Application No. 10/582,809 Paper Dated: December 4, 2008

AMENDMENTS TO THE DRAWINGS

REMARKS

"Pipe Joint Construction" Inventors: Mitsuhiro Mori et al. Attorney Docket No.: 0388-061722

Fig.1

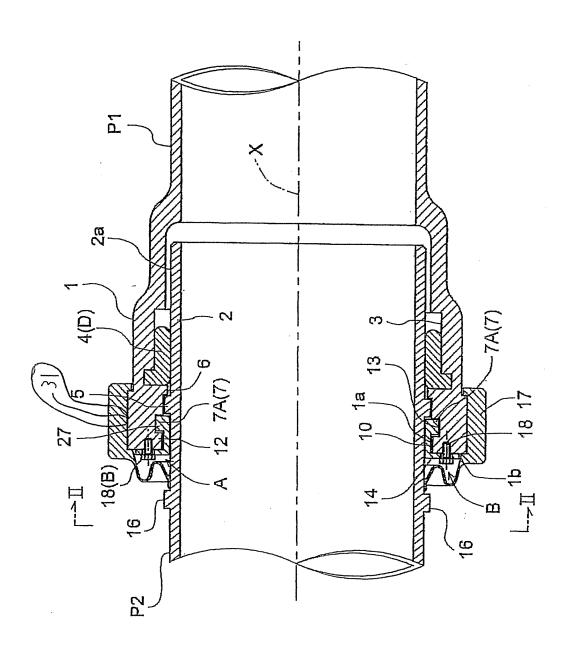
The drawings stand objected to for minor informalities. Specifically, the Examiner has objected to the drawings for failing to comply with 37 C.F.R. §1.84(p)(4) because reference character "27" has been used to designate both the flange-shaped attaching portion in Figs. 1, 15 and 22 and the engaging pieces in Figs. 16 and 17, and reference character "15" has been used to designate both the control pinching portion in Figs. 2-5, 13 and 17 and the control knobs in Figs. 18 and 19. The Examiner has also objected to Fig. 25 for lacking a legend such as --Prior Art-- because only that which is old is illustrated. Finally, the Examiner has objected to Fig. 1 because the line for reference character "27" appears to be pointing to the wrong area.

The Applicants believe that replacement Figs. 1, 15, 22 and 25, along with the above amendments to the specification, overcome the Examiner's objections. Amendments to Figs. 1, 15, 22 and 25 are indicated in the attached annotated copies of Figs. 1, 15, 22 and 25. Reconsideration and withdrawal of these objections is respectfully requested.
